**AGENDA**  
Regular Hybrid Meeting  
Town of Granby  
Inland Wetlands and Watercourses Commission  
Thursday, February 13, 2025, at 7:00 pm  
Town Hall Meeting Room

**Wetlands Application Plan Review**  
February 6, 2025

Breezy Meadow Subdivision, Prepared for Peak Mountain Development, LLC, 188 Day Street, December 23, 2024, Sheets: SD-1, GR-1, GR-2 E&SC-1, E&SC-2, Notes-1, Alford Associates, Inc.

RAIN GARDEN SECTION -  
NOT TO SCALE

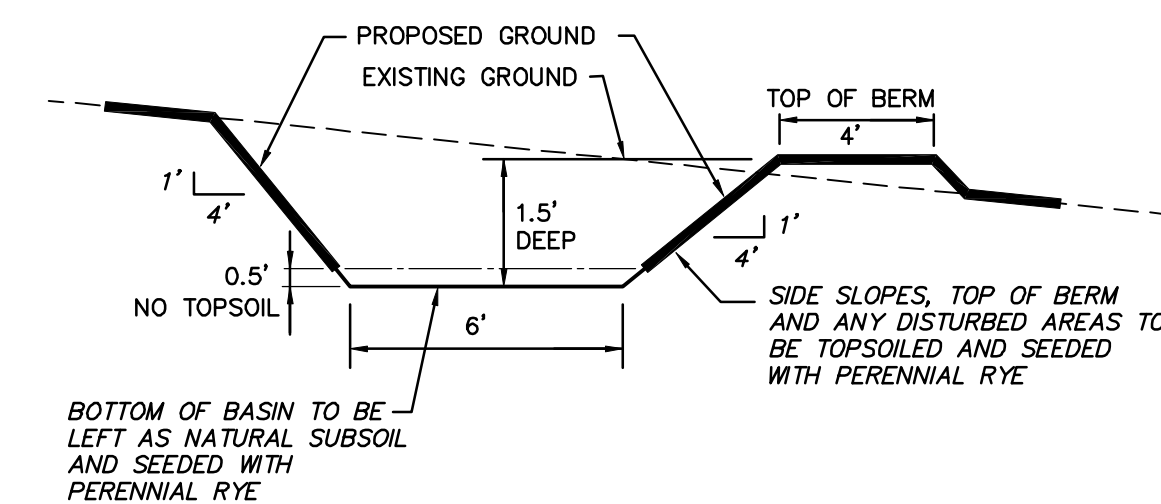
- b. Verify the URA shown for Wetland #1 as it relates to the URA for the watercourse and wetlands show separately where they differ.
  - c. Rain garden construction details which include the type and depth of substrate and vegetation.

- d. Depict and detail how the rain gardens will be protected or utilized during construction in addition to how they will be maintained in perpetuity.

Sheet  
GR-3

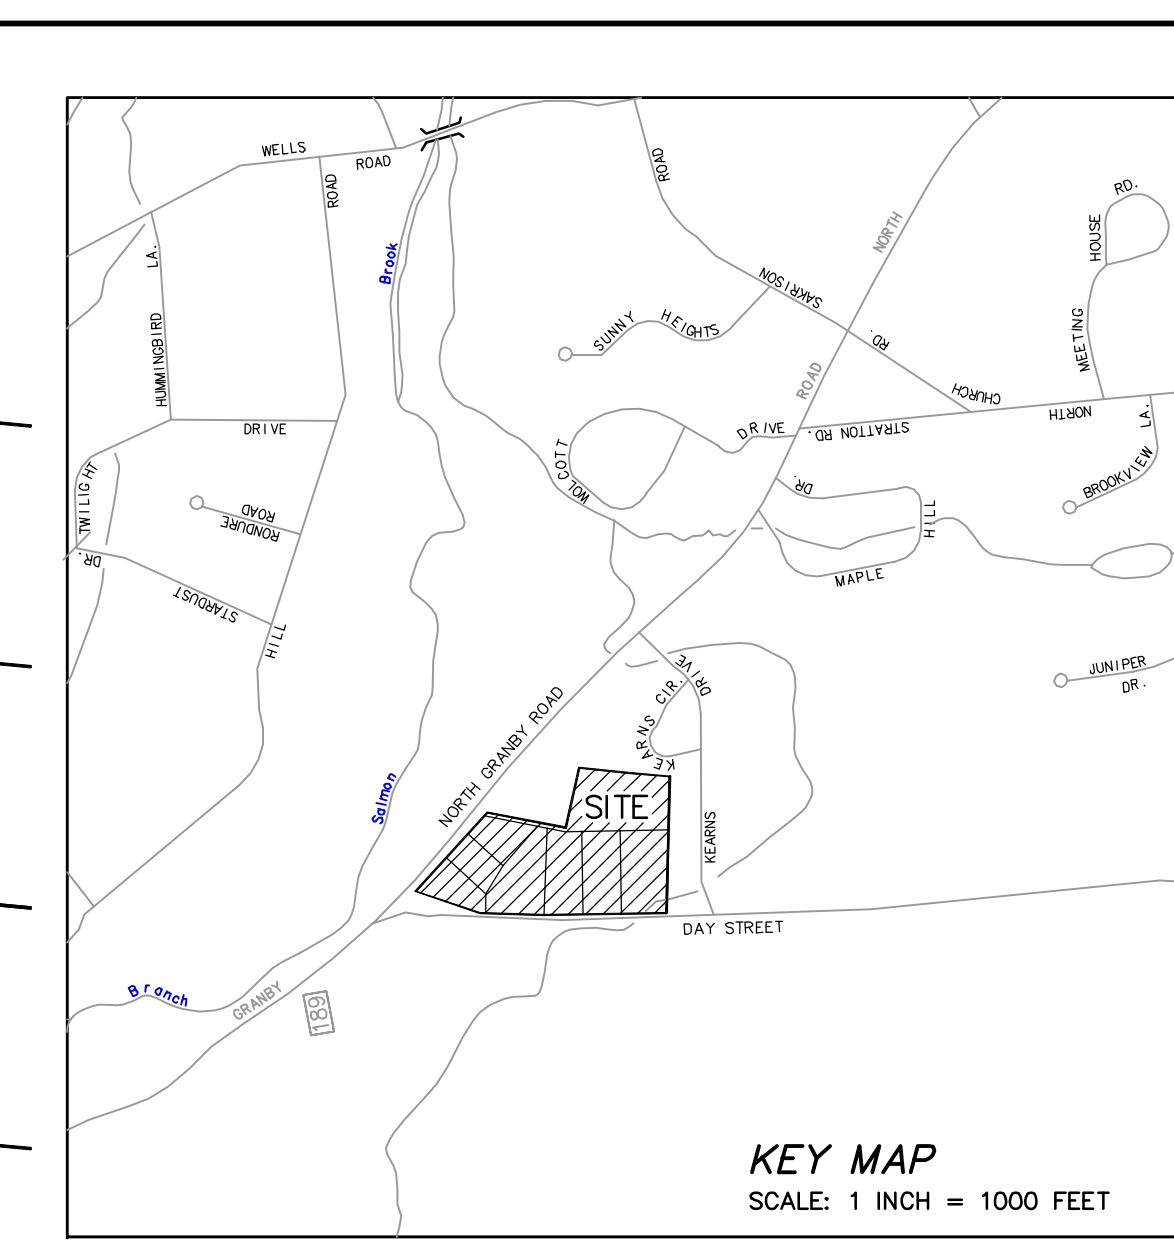
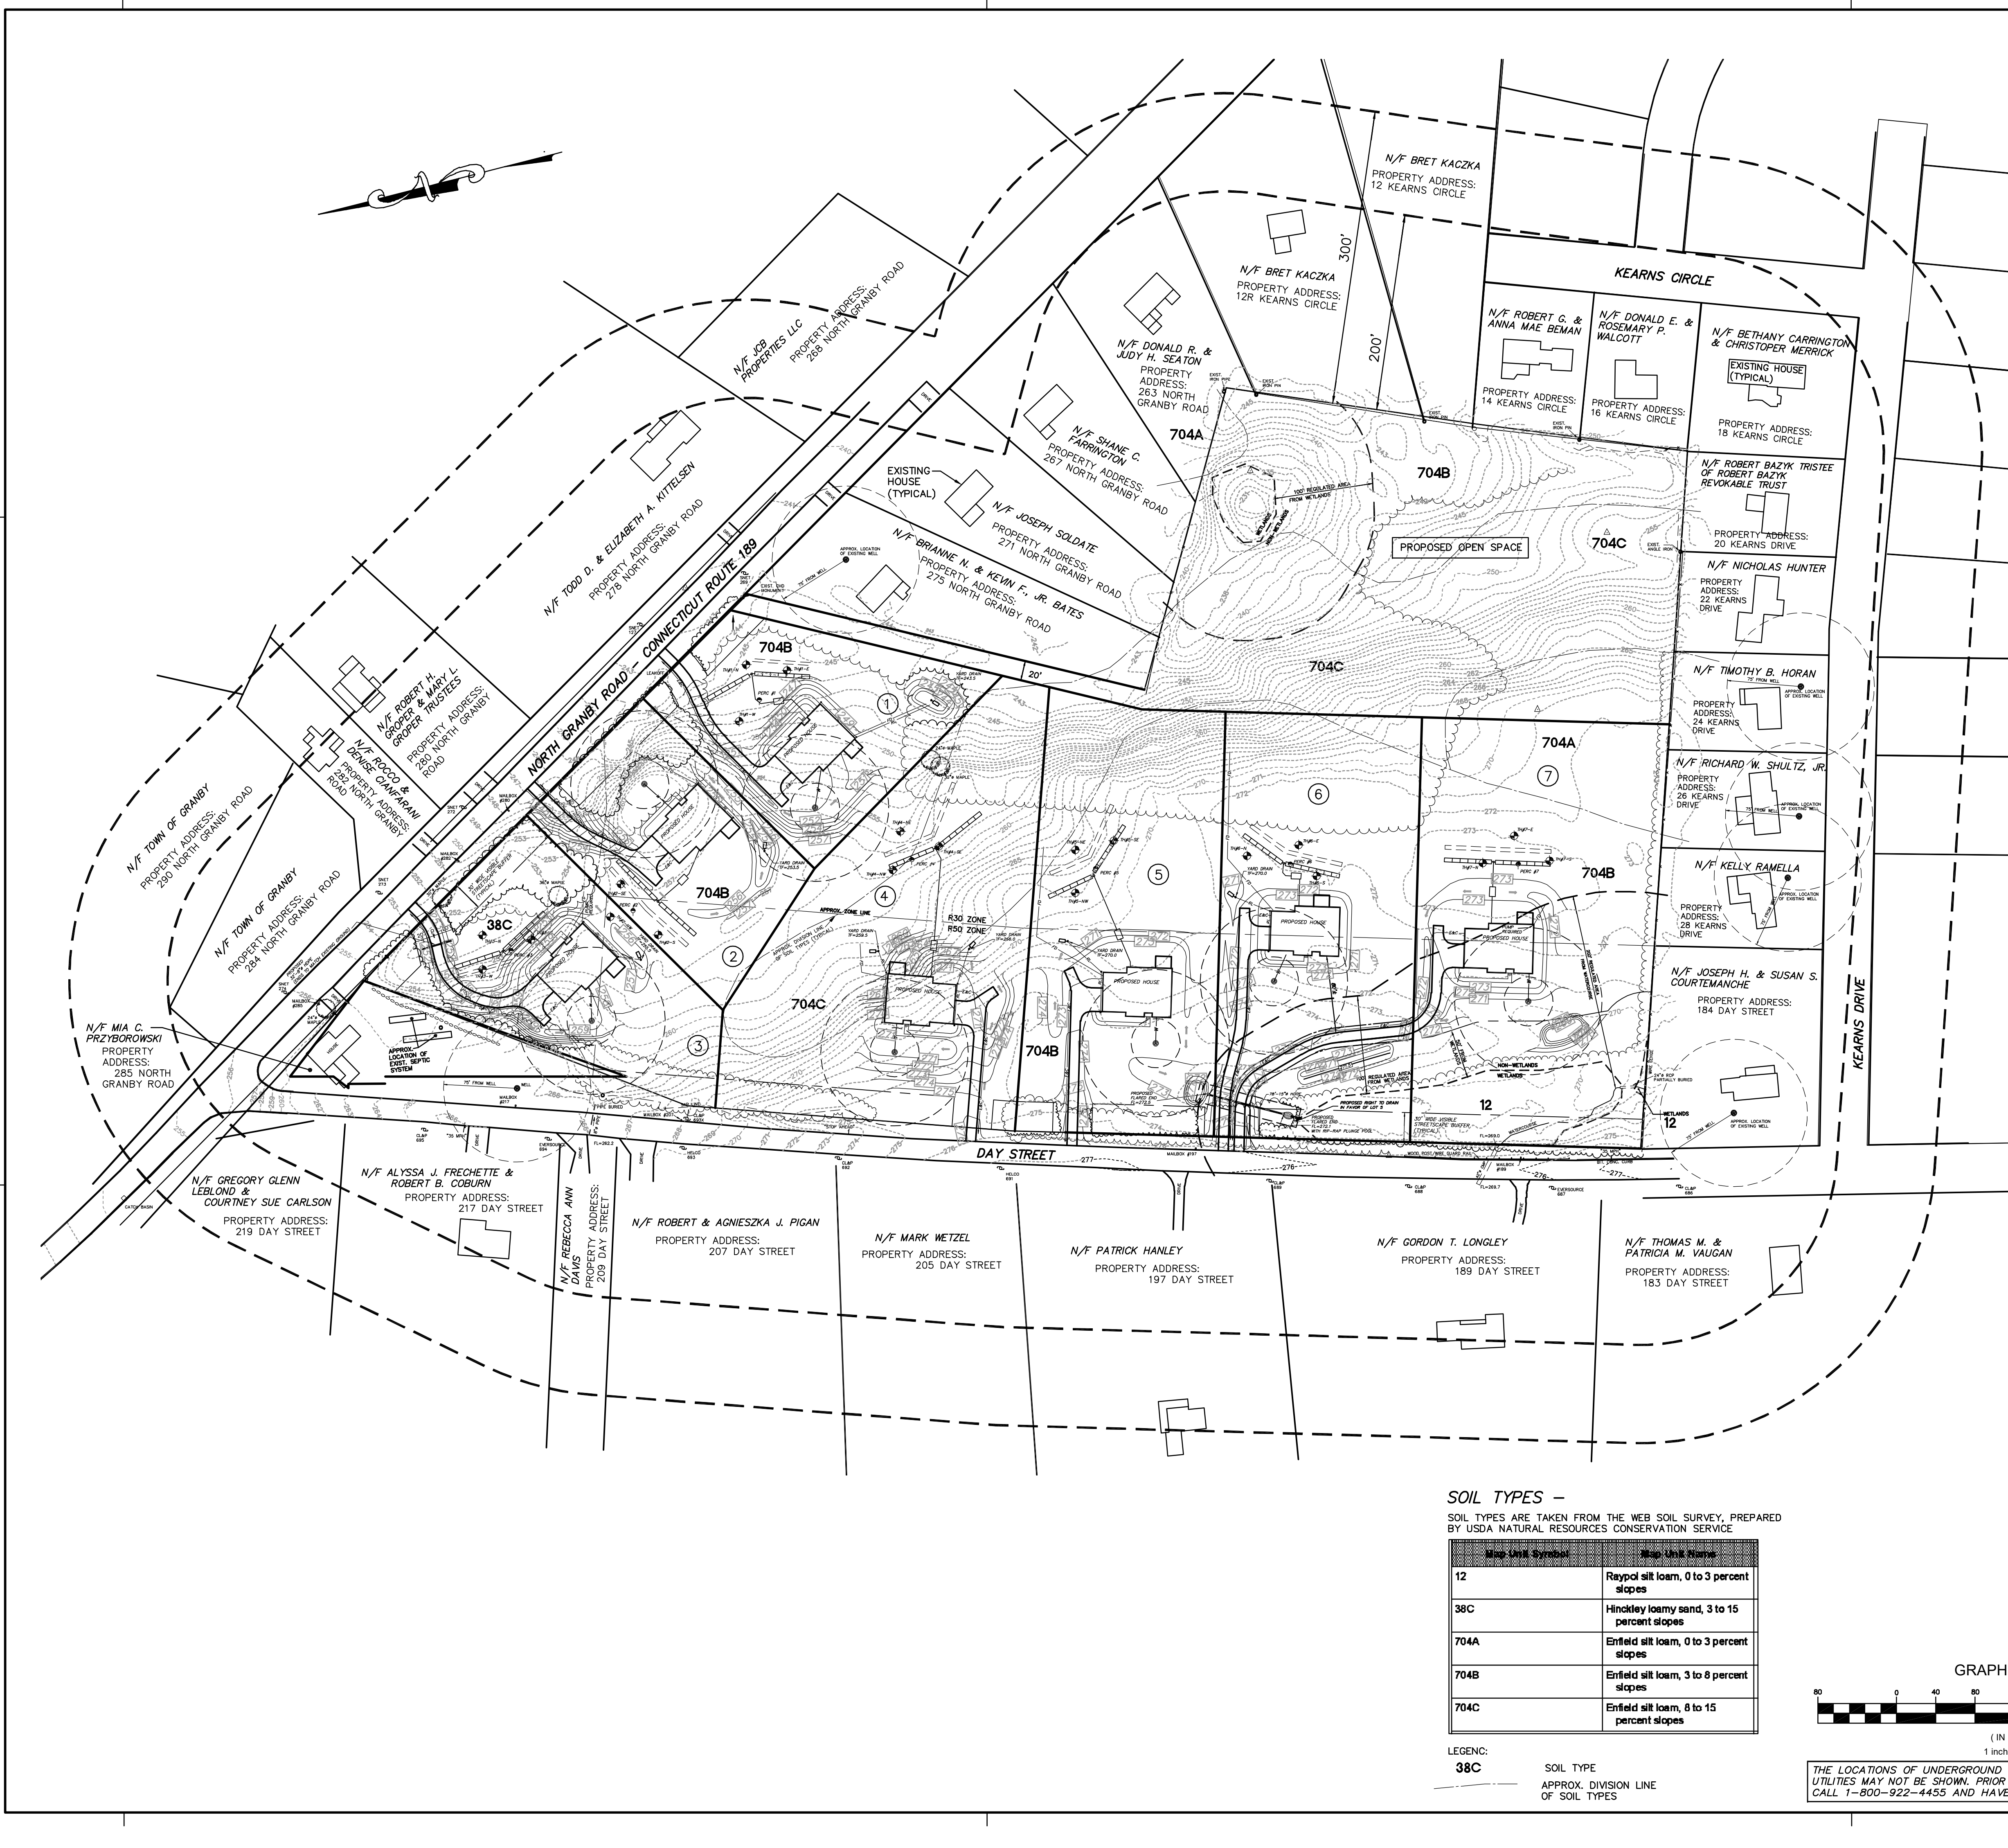
I've taken a quick look at the revised plans that show the removal of the 24-in culvert and restoring the farm road at the wetlands crossing. My concern is that it may adversely impact the drainage conditions on the adjacent property and the undersized culvert at Kearns Drive. This is because the farm road is providing some stormwater storage that could be reducing the peak flows downstream. If the developer decided to remove the culvert and the farm road, I would want a study showing what the impacts are on the downstream property and the culvert at Kearns Drive. If they decide to leave things as they are, I want to see the extent of the potential flooding on their property as noted in comment 11 of my review dated 2/6/2025.

I also noted that they have removed the proposed pipe under the new driveways to lots 6 and 7. They should show a 6-inch overflow pipe draining from the rain garden on lot 5 to the one on lot 6.

### INFILTRATOR CHAMBER

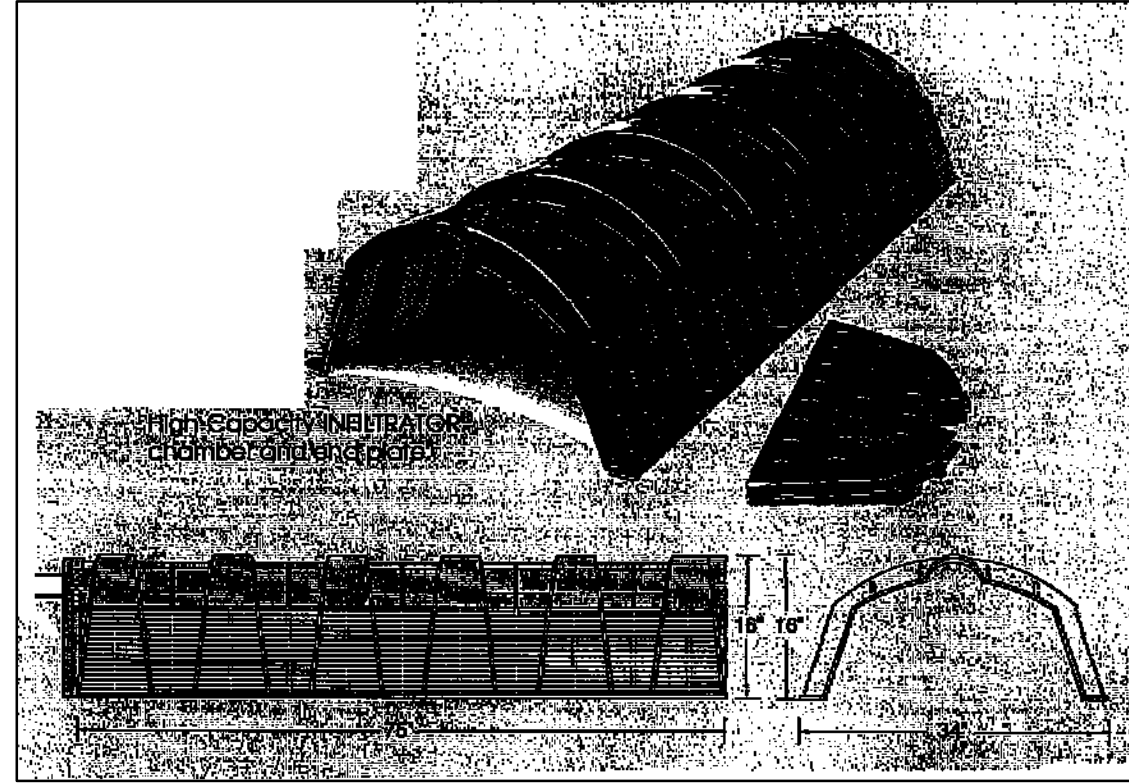
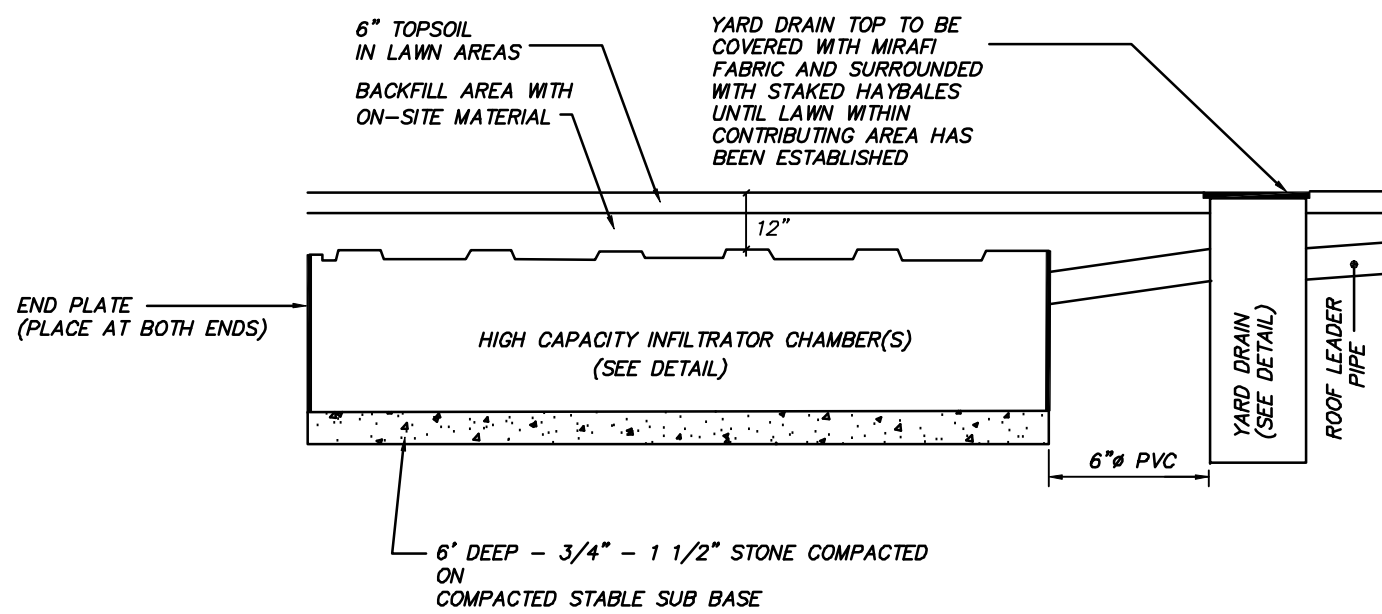
6. Show one line for the highway line on North Granby Road.
7. Refer to latest Infiltrator web page for current products and details for roof drainage. Add a wye with a splash block just above the ground elevation to provide relief if the infiltration system clogs.
